## Monks Orchard Residents' Association Planning

Reference: 21/05741/FUL  
Application Received: Tue 16 Nov 2021  
Application Validated: Tue 16 Nov 2021  
Address: 46 The Glade Croydon CR0 7QD  
Proposal: Demolition of a single storey dwelling and redevelopment with a new building to provide 9 dwellings (Class C3), with associated amenity space, integral refuse, cycle stores and external car parking.  
Status: Awaiting decision  
Consultation Expiry: Thu 23 Dec 2021  
Determination: Tue 11 Jan 2022  
Case Officer: Christopher Grace

Please accept this letter as a formal objection to **Application Ref: 21/05741/FUL** for Demolition of an existing two bedroomed four-person bungalow with assumed 4 habitable rooms and presumably 4 bedspaces equating to a Housing Density of **≈9.80Units/ha** and a Residential Density of **≈39.22hr/ha or ≈39.22bs/ha** in a **PTAL of Zero at 46 The Glade**, with a new building of 9 dwellings (Class C3), with associated amenity space, integral refuse, cycle stores and external car parking.

**Illustration of Design Code evaluation of 'Settings' at Local Area for 46 The Glade with Site area of 0.102hectares at PTAL Zero**

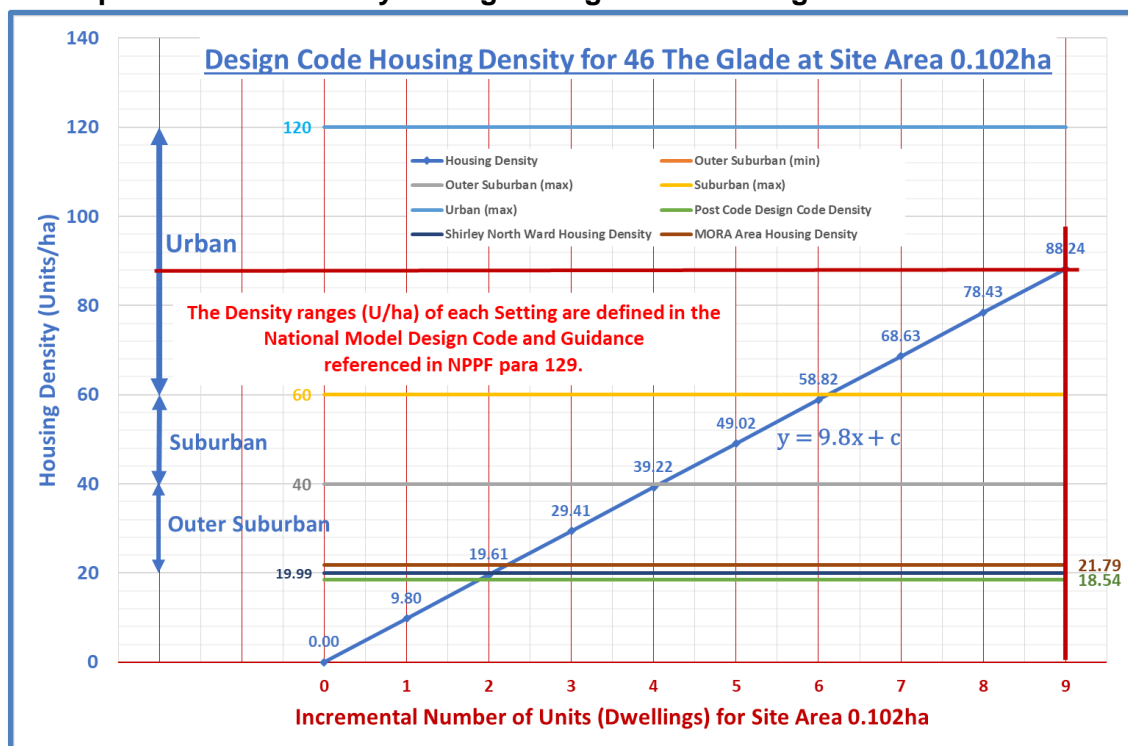
2.2.8 The evaluation of this proposal places **46 The Glade** with **9 dwellings** of Housing Density at **88.24Units/ha** clearly within the mid-range of an **'Urban'** **'Setting'** whereas the **locality** by the various local **Area evaluations** is well within or even below the **Outer-Suburban Design Code 'Setting'**. Additionally, at a Residential Density of **313.73 Bedspaces/ha** at a **'Central' Setting (even worse)** when the actual Setting is **'Outer Suburban'**. This clearly shows the **'Site Capacity'** of **0.102ha** is extremely overdeveloped at 9 dwellings. **Shirley is clearly not 'Urban' and definitely not 'Central' as proved by these assessments:**

**Graphical illustration of PTAL requirements for the proposed development at 46 The Glade with Residential Densities based upon the TfL data and Office for National Statistics (ONS) data for Unit Occupancy.**

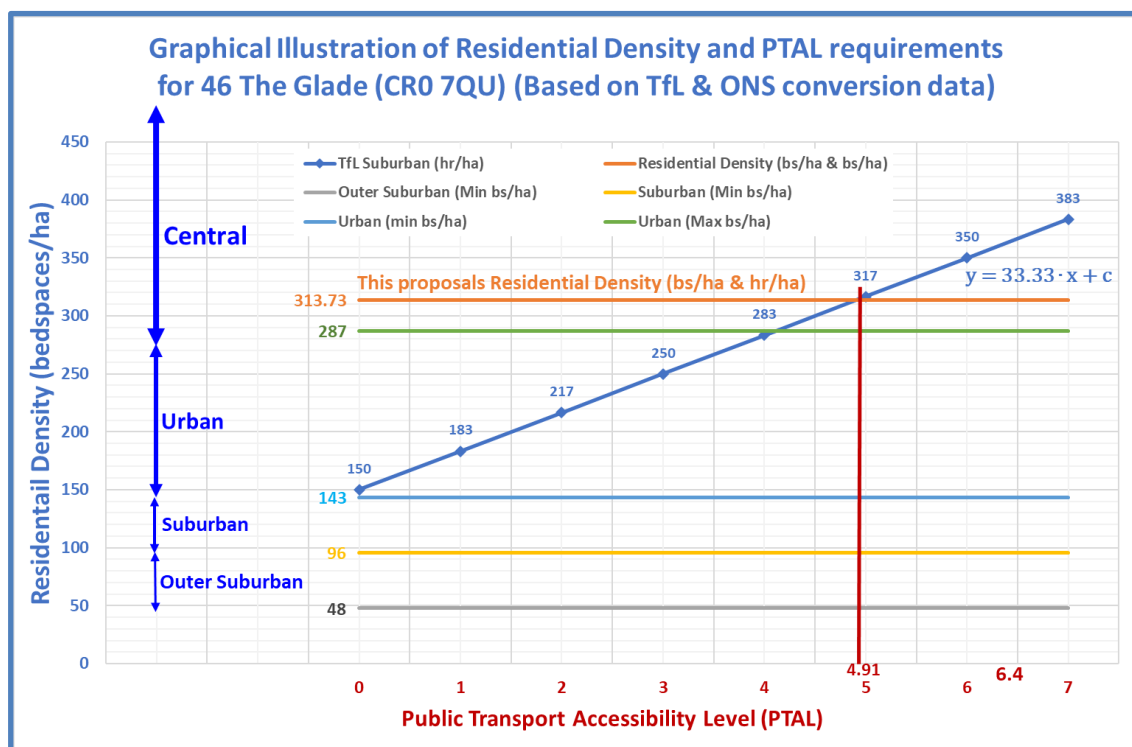
## 5.5 Therefore, the required PTAL for this proposal is 6.4 when the actual available PTAL is Zero and remains at Zero until at least 2031 for this Post Code or Address.

## 5.6 This assessment provides clear evidence that the proposal at occupancy of 313.73bedspaces/ha or hr/ha would require a **PTAL** of 4.91 which is clearly ‘unsustainable’ and unacceptable at the ‘Design Code’ and ‘Setting’ of the Locality.

#### Analysis of Parking Provision

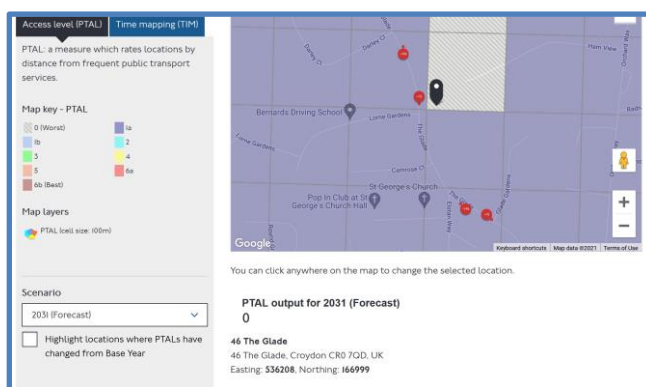
7.6.1 The analysis shows that for new developments in areas without controlled parking Zones and at **PTAL Zero**, would be **10 spaces** for the Revised draft **Croydon Local Plan Policy DM30 Table 10.1** and **13.5 ≈14 spaces** for the adopted **London Plan Policy T6.1 Table 10.3** when only **7** are provided.

This is a **42.86% deficiency** for the Revised Draft Croydon Plan and a **92.86% deficiency** for the London Plan Policy.

- 7.6.2 From this analysis, the Residential Parking provision is inadequate for a **nine flatted development** at a **PTAL Zero** locality and therefore the proposal should be rejected as it would likely generate at least 3 car overspill (Revised Local Plan) onto adjacent streets. This would be extremely hazardous if overspill parking were to be on The Glade (the 367 Bus Route) as the Glade provides a busy link between the A232 (Wickham Road) and the A222 (Long Lane). Further, occupants may use the Lorne Garden residential street for overspill, but the possible overspill may be combined with the redevelopment of 81 The Glade (Opposite 45 The Glade) Application Ref: 21/00108/FUL which although refused at committee is pending an appeal.

**Roof Form showing inappropriate Vertical Rear Elevation structure.**

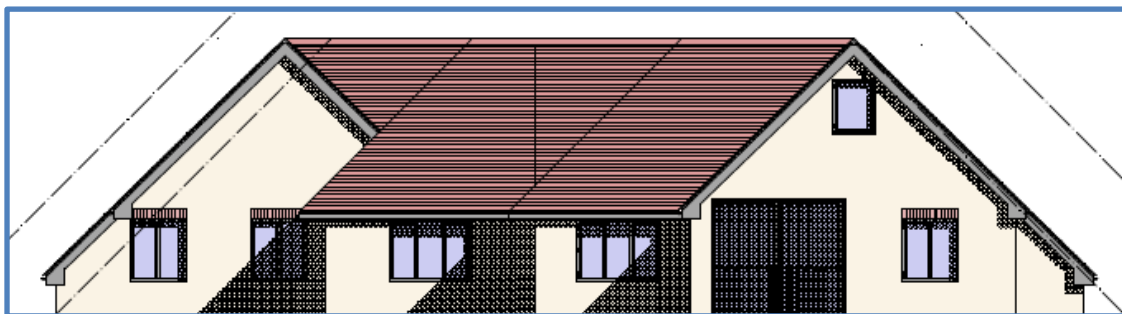
- 9.1 The Rear elevation **Roof Form** has a vertical elevation, presumably housing the Lift motor and mechanism, which looks **odd** from the view as presented to the rear.
